ITEM 4. DEVELOPMENT APPLICATION: 19-29 MARTIN PLACE SYDNEY - MLC CENTRE**FILE NO: D/2015/66****DEVELOPMENT APPLICATION NO: D/2015/66****SUMMARY**

Proposal Summary: The proposal seeks consent for substantial alterations and additions to the basement and podium levels (being Levels 1 to 9) of the MLC Centre at 19-29 Martin Place, Sydney. The scope of works includes:

Figure 24 - Level 9 floor plan illustrating location of new podium plant in relation to 5 Martin Place

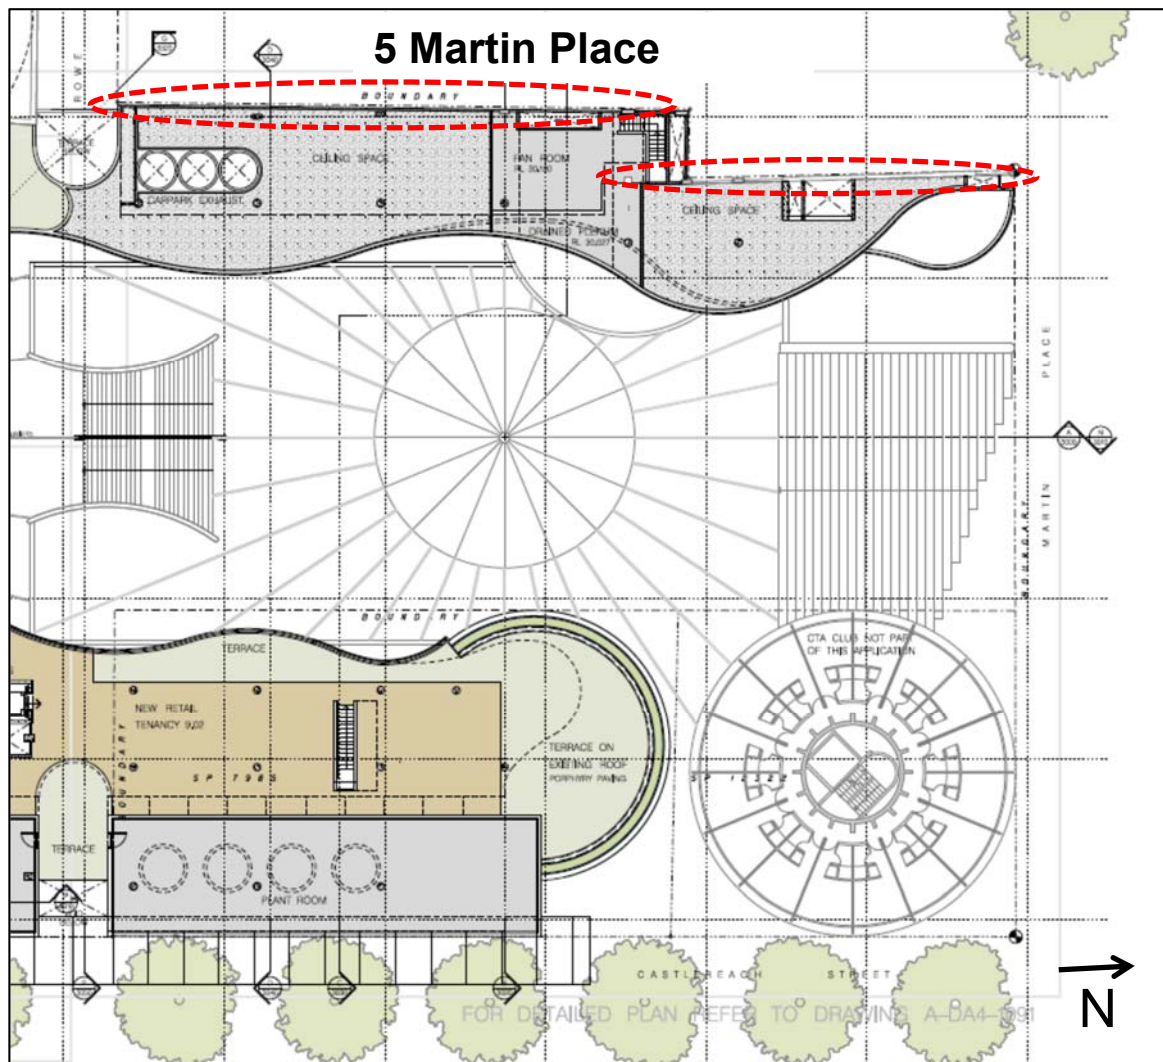
40. A submission has been received by the adjacent property (known as 5 Martin Place) in relation to the interface of this podium addition on the western side of the plaza with the recently completed addition to their site. Concern has been raised that the siting of this podium, in particular the Level 9 plant and ceiling space, would obstruct natural light into the Level 2 eastern elevation windows of the commercial office at 5 Martin Place (refer to **Figure 24**, below).

41. The submission has requested that the plant level of the subject site be setback 900mm from the shared boundary to allow the retention of natural light to this office floor and into the glazed roof of the through site link (see **Figure 25**, below).

42. In this instance, it is not considered that a provision to the set the new podium levels back from the western boundary is warranted as:
- (a) at the time of assessment of the development application for the redevelopment of 5 Martin Place (being D/2009/1386), an objection was made on behalf of the owners of the MLC Centre. This objection related to the nil setback of the addition at 5 Martin Place from the eastern boundary, notably the siting of new windows on the common boundary. As a consequence, the application was approved with a boundary window covenant condition as follows:

Figure 26: Sectional drawing illustrating the interface of the proposed podium addition with the eastern elevation of 5 Martin Place

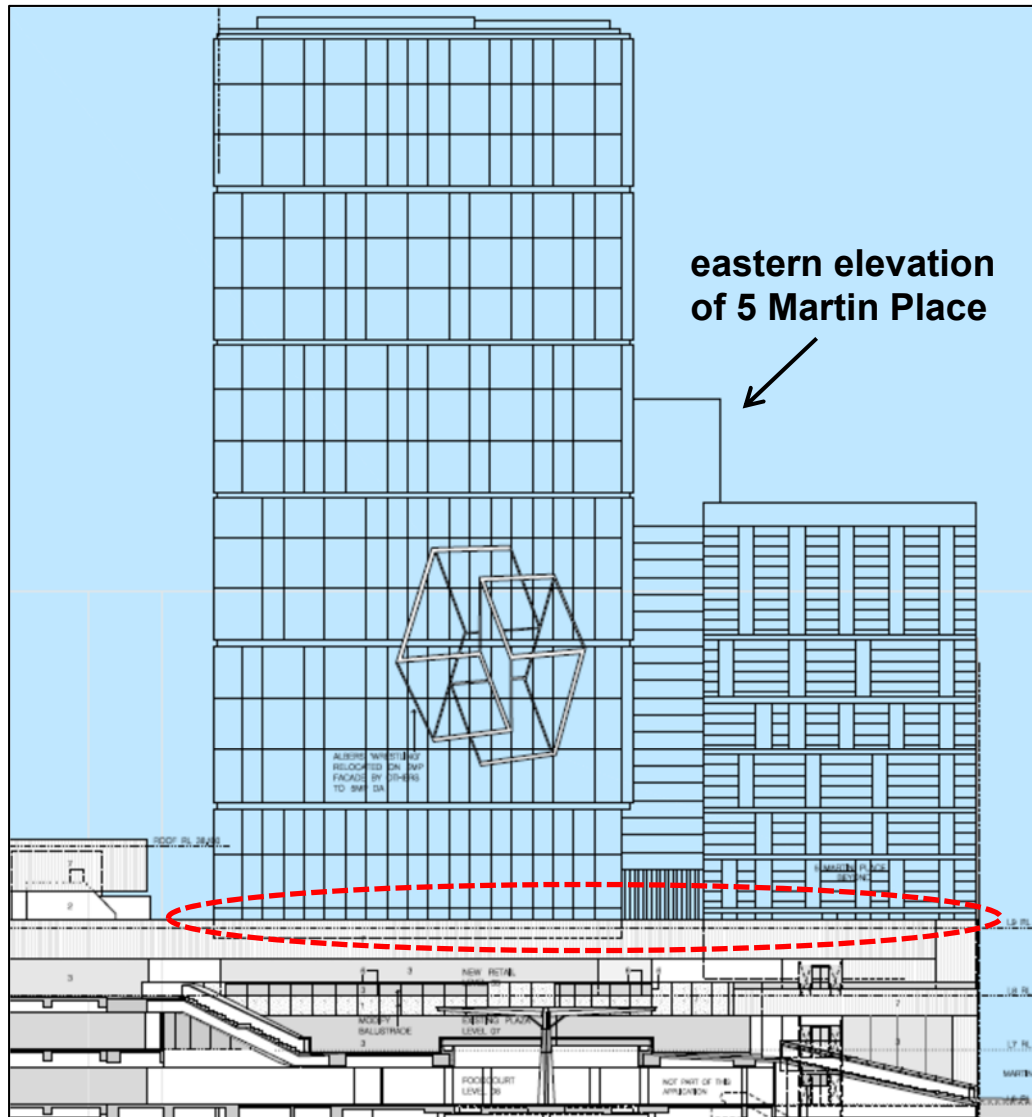
- (c) the impact of the proposed podium addition on the eastern elevation windows of the adjacent commercial building at 5 Martin Place is limited to one floor of the commercial building. As is evident from **Figure 26**, above, the proposed Level 9 plant level does not wholly obstruct the eastern elevation windows of Level 2 of 5 Martin Place. The terms of the covenant allow Council to require that these eastern elevation windows be bricked up or sealed in the event of the redevelopment of the MLC Centre site. As these level 2 windows are not being wholly obstructed, it is considered that the tenants of 5 Martin Place are still benefitting from the natural daylight that will still be received through these windows. This is considered to be a better alternative than bricking up these windows;

Figure 28: The portion of the western podium addition that is located within 20 metres of Martin Place

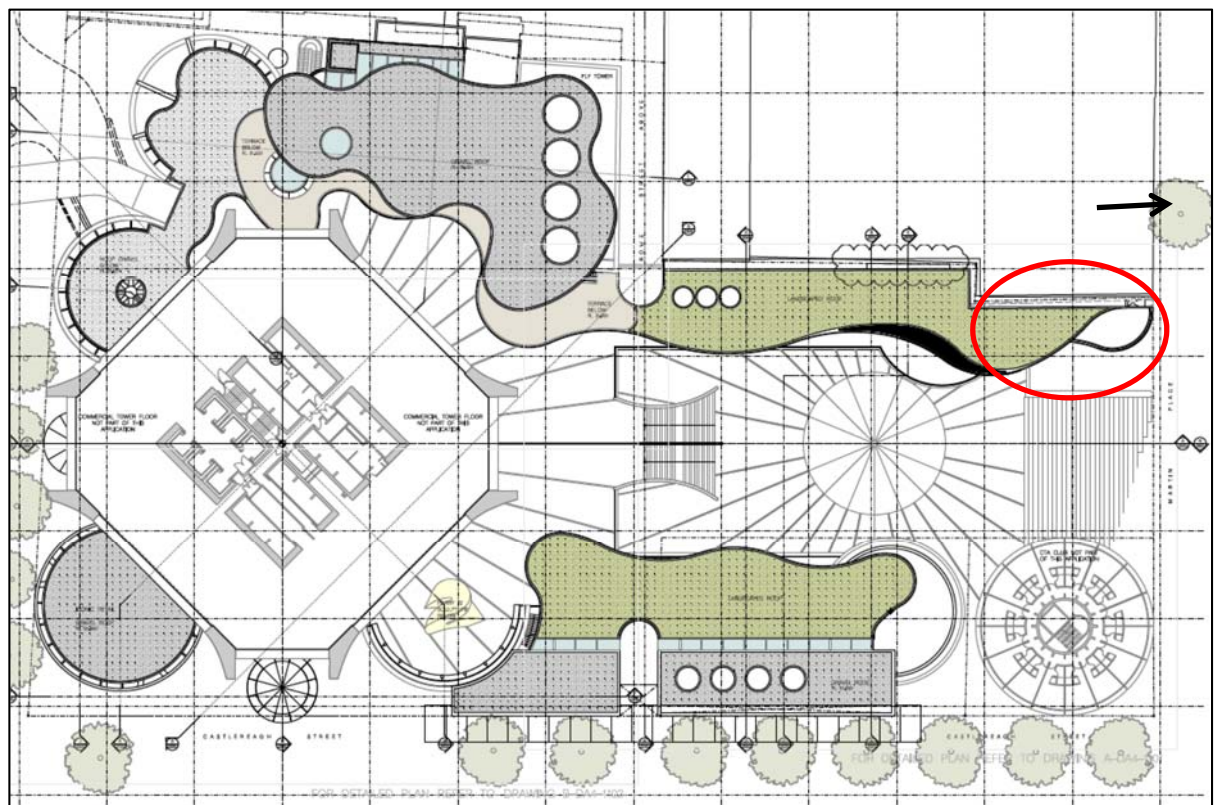
50. It was recommended from a heritage perspective that the podium addition (levels 7 to 9) on the western side of the plaza be setback 20 metres from Martin Place (refer to **Figures 28** and **29**, below). It has been recommended from a heritage perspective that the form of the podium additions should be amended to be an orthogonal form and to be clad in white quartz aggregate to match the original MLC Centre.
